Addendum NO. 2

PROJECT: A New Hotel For: Terra Development LLC
Date: June 9, 2022

A0-5

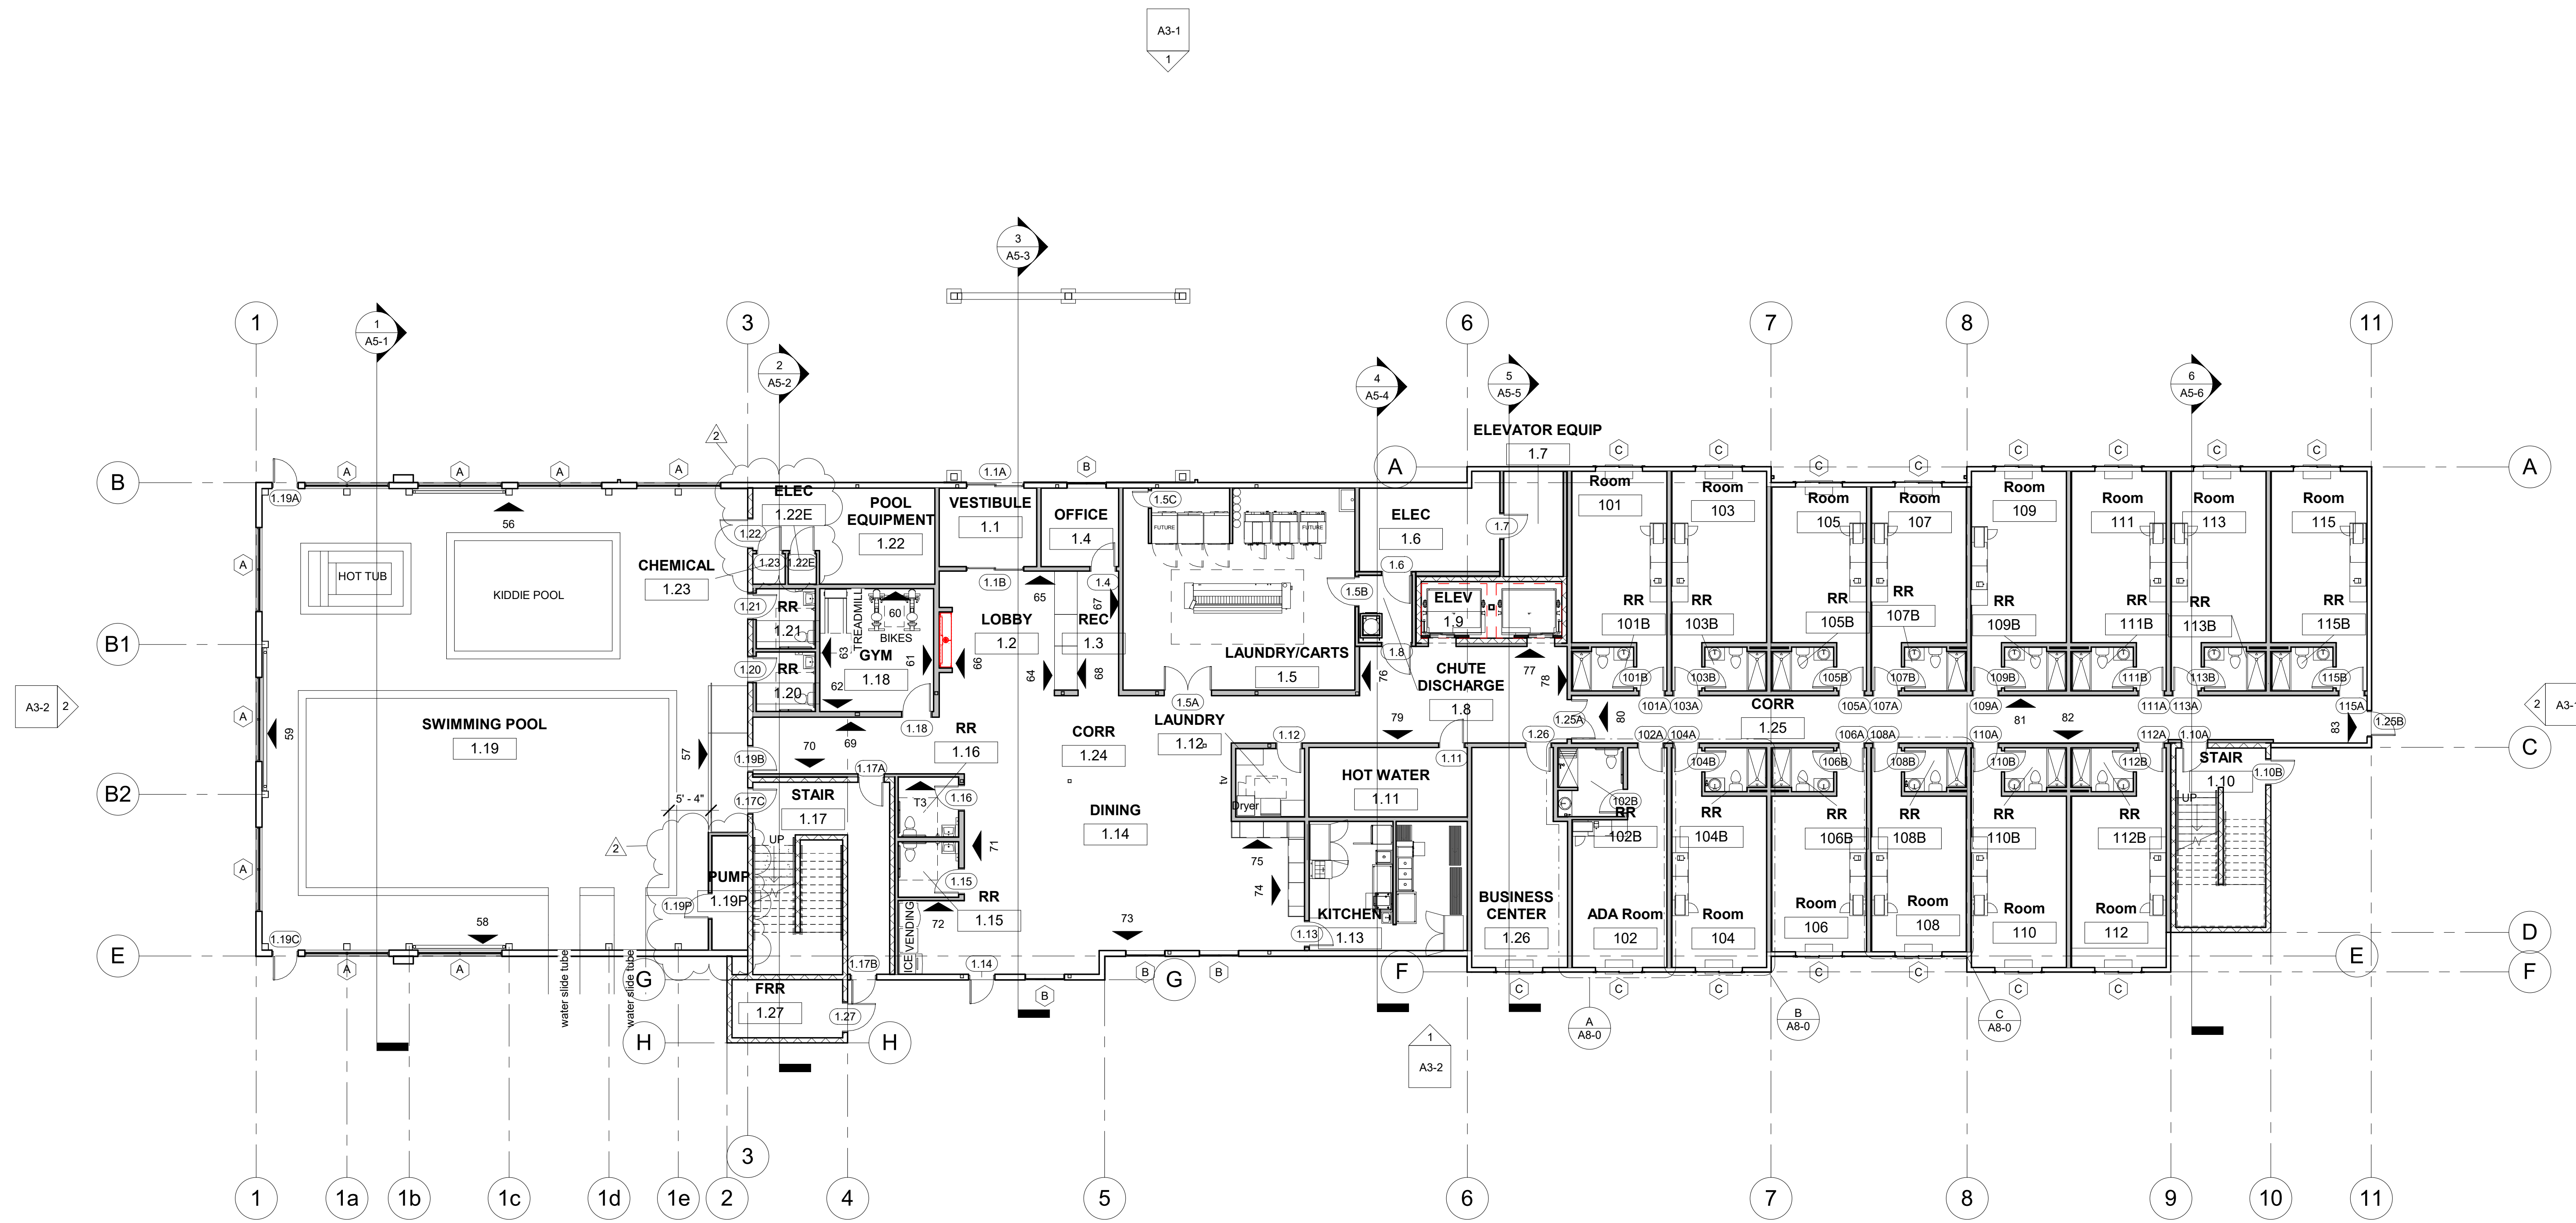
REVISE Sheet A0-5 per Attached.
REVISE Sheet A2-1 per Attached.
REVISE Sheet A2-6 per attached.
REVISE Sheet A2-7 per attached.
REVISE Sheet A2-13 per attached.
REVISE Sheet A2-24 per attached.
REVISE Sheet A6-0 per attached.
REVISE Sheet A7-0 per attached.
REVISE Sheet A8-2 per attached.
REVISE Sheet A8-3 per attached.
REVISE Sheet A9-0 per attached.
REVISE Sheet A9-3 per attached.
REVISE Sheet A9-4 per attached.
REVISE Sheet A10-7 per Attached.

A9-0

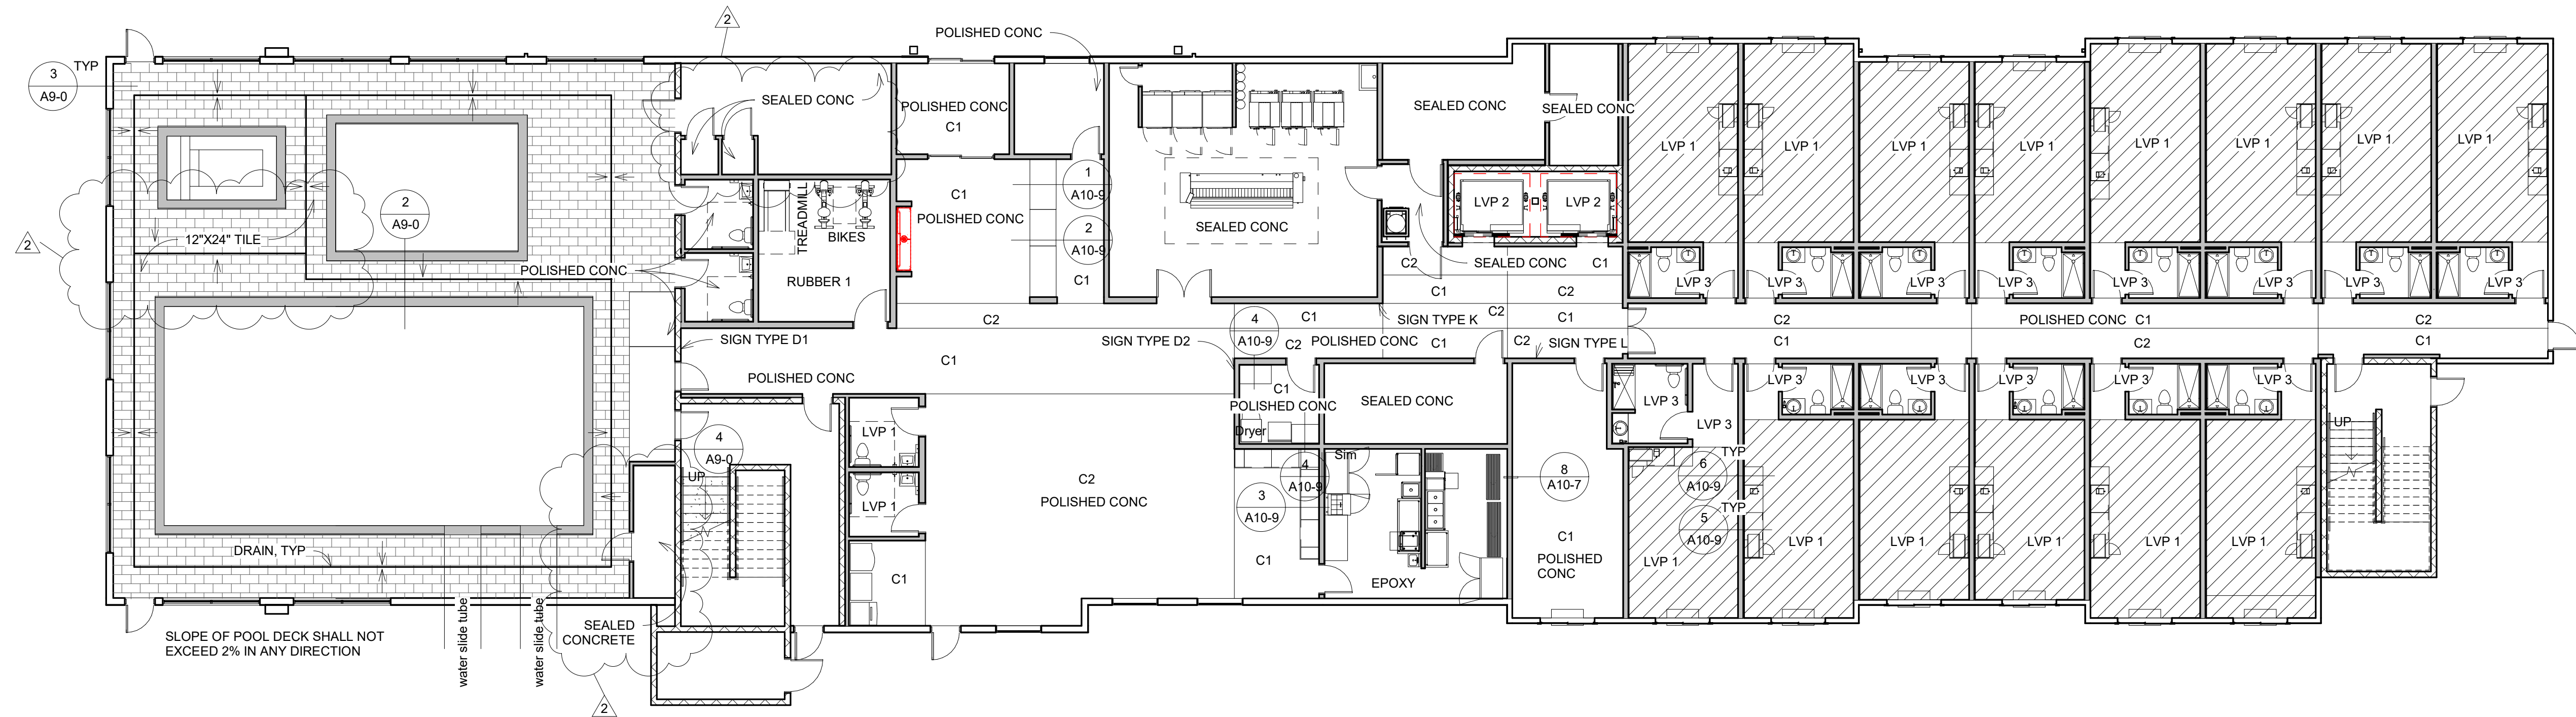
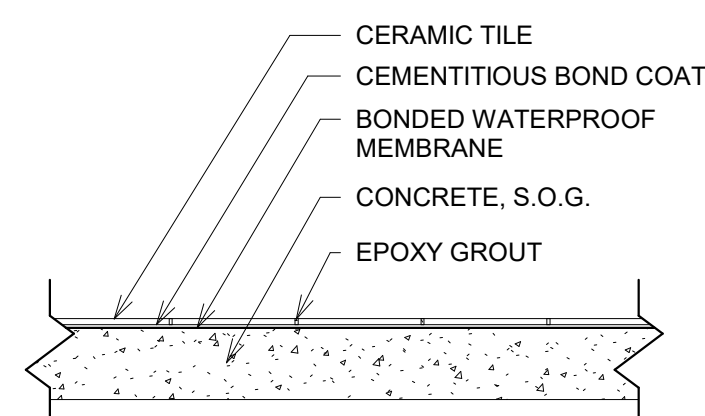
1. Floor Tile:
 - a. Swimming pool and water slide chute rooms (**running bond pattern**)
 - 1) Crossville, Feel Stripes
 - 2) Size: 12 X 24
 - 3) Color: Ivory
